# **EPA Superfund Explanation of Significant Differences:**

**COMMENCEMENT BAY, NEAR SHORE/TIDE FLATS  
EPA ID: WAD980726368  
OU 01  
PIERCE COUNTY, WA  
02/04/2002**

**EXPLANATION OF SIGNIFICANT DIFFERENCES  
MIDDLE WATERWAY  
COMMENCEMENT BAY NEARSHORE/TIDEFLATS SUPERFUND SITE  
FEBRUARY 2002**

Figure 2  
Middle Waterway Problem Area  
SMUs Requiring Remediation,  
Natural Recovery, and/or No Action

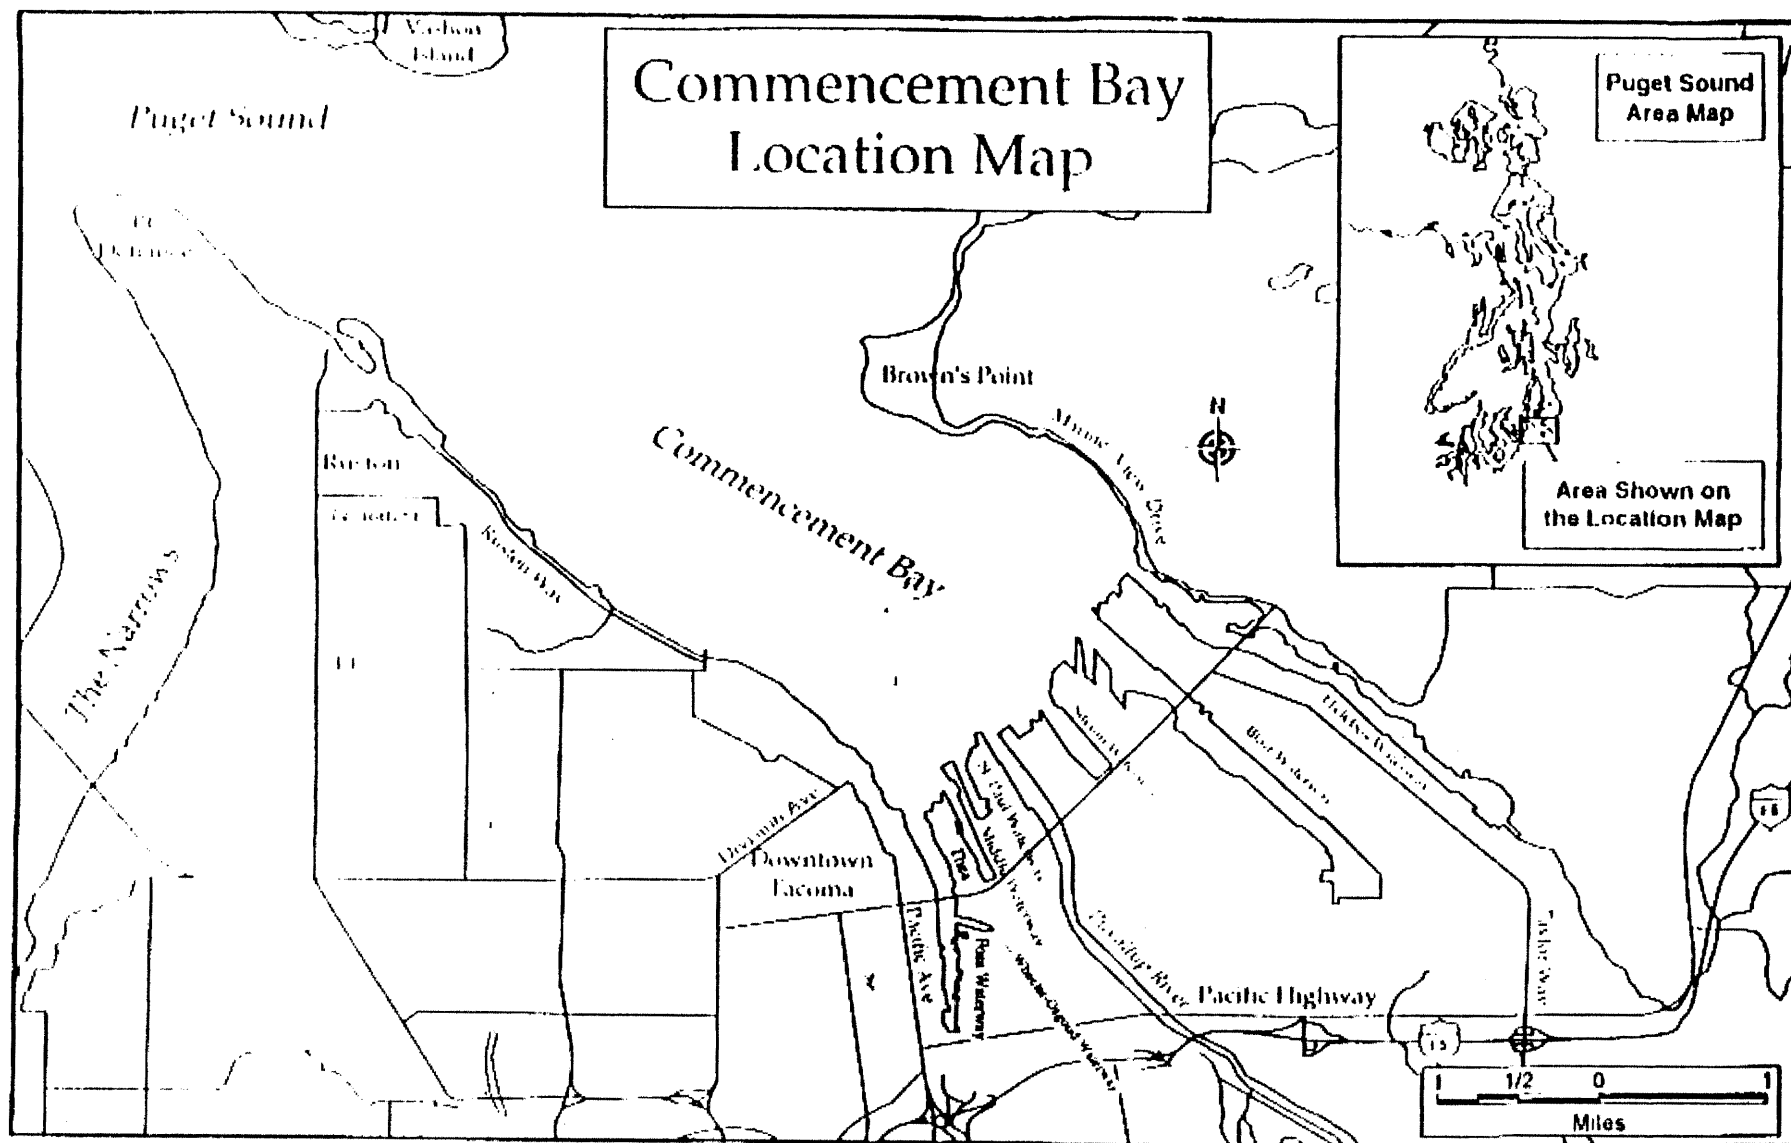
**4. Comment:** Figure 2 and Appendix B. The draft ESD and Final Evaluation of Remedial Options Report (November 2000) do not provide cross-sections of detailed information on the dredge prism and the effect of no action/natural recovery on navigation in SMUs 8 and 10-14, which is the active public navigational portion of the waterway.

**41. Comment:** Section V. A. Area A, pg. 7. In the text, problem sediments in SMU 15a will be dredged, but Figure 2, shows this area as no action. Please correct Figure 2. (*NOAA*)

**68. Comment:** In addition, please correct Figure 2 and remove the reference to Simpson Tacoma Kraft Company, as we have previously requested. Simpson Tacoma Land Company is a separate corporation and is the owner of this property. *(Simpson)*

**72. Comment:** The ESD should also note on page 6 that there is essentially no cleanup required on the Middle Waterway tidelands owned by Simpson Tacoma Land Company (see dotted property line on Figure 2 of draft ESD). *(Simpson)*

**Response to Comments 41 through 43:** While these SMUs are not designated for comprehensive dredging, the sideslopes of these SMUs, the areas most closely associated with the SQO exceedances, will be removed in connection with dredging in adjacent SMUs. This is documented in footnote 3 to Figure 2 in the ESD.
